*Preliminary Consultation*  
**MONTGOMERY COUNTY HISTORIC PRESERVATION COMMISSION**  
**STAFF REPORT**

<b>Address:</b>	7417 Maple Ave., Takoma Park	<b>Meeting Date:</b>	3/11/2020
<b>Resource:</b>	Contributing Resource <b>Takoma Park Historic District</b>	<b>Report Date:</b>	3/4/2020
<b>Applicant:</b>	David Bend	<b>Public Notice:</b>	2/26/2020
		<b>Tax Credit:</b>	No
<b>Review:</b>	Preliminary Consultation	<b>Staff:</b>	Michael Kyne
<b>Case Number:</b>	N/A		
<b>PROPOSAL:</b>	Window replacement

***Fig. 1: Subject property.***

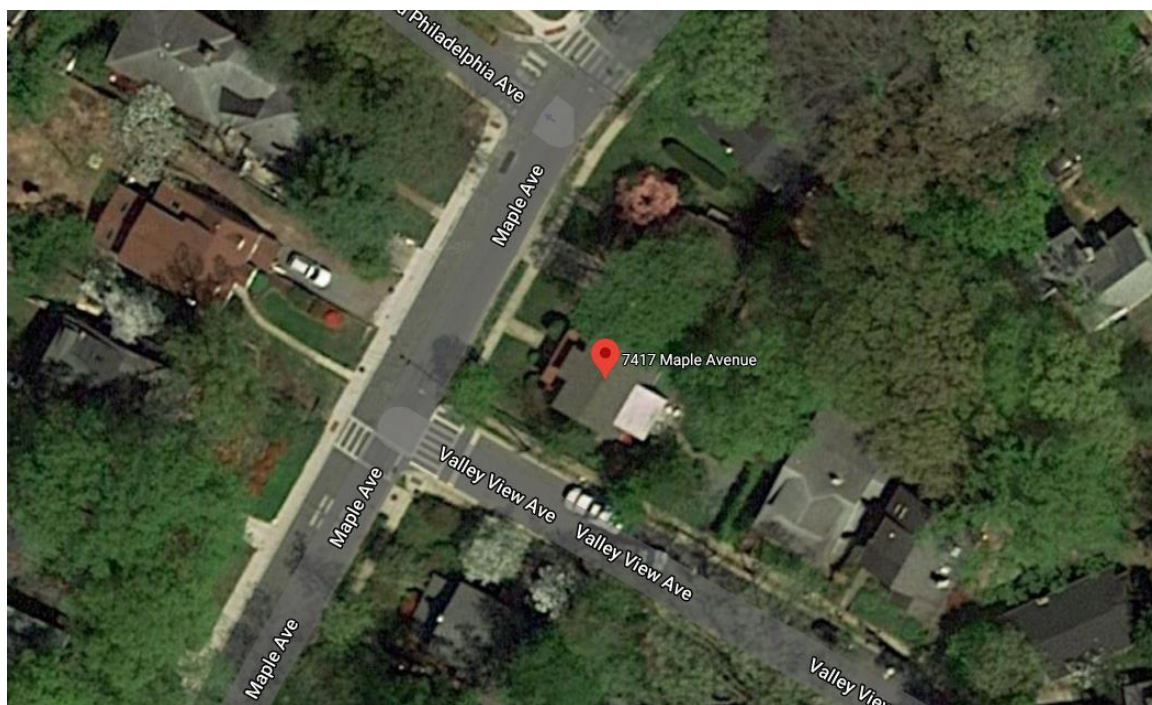
On the second-floor, the windows to be replaced include two windows on the south (right) elevation, two windows on the north (left) elevation, and two windows in the dormer on the west (front) elevation. All of the windows are original six-over-six double-hung wood windows.

At the basement-level, two windows are proposed to be replaced on the south (right) elevation, and one window is proposed to be replaced on the north (left) elevation. The windows to be replaced on the south (right) elevation include one six-lite wood casement window and one two-lite wood awning window. The window to be replaced on the north (left) elevation is a four-lite wood casement window. The six-lite wood casement window on the south (right) elevation is original to the house and is consistent with the style of the six-over-six double-hung windows on the upper floors. The four-lite wood casement window on the north (left) elevation also appears to be original to the house, as it is consistent with two four-lite casement windows directly above it on the first-floor. The material and weathering of the two-lite awning window on the south (right) elevation is consistent with the other windows.

Staff visited the subject property on Wednesday, February 19, 2020 to assess the condition of the windows to be replaced. Staff found many of the windows had peeling paint, one basement-level window was in clear need of weatherization, one second-floor window had a cracked pane of glass, and another second-floor window had a broken sash cord. Overall, however, the windows were in good condition and repairable.

Given the good, repairable condition of the windows, LeadProbe, Inc.'s test results and recommendation, and the guidance provided by HUD and the National Park Service, staff does not support the proposal to replace the original windows at the subject property. Staff finds the proposal inconsistent with the *Standards* – specifically, *Standards* #2, #5, #6, and #9, as cited on Page 4. Staff recommends that the applicant work with an experienced historic window restoration contractor to repair the windows and to stabilize or abate the lead-based paint, per the contractor's recommendations.

Staff recommends that the applicants make any revisions based upon the HPC's comments and return with a HAWP application.
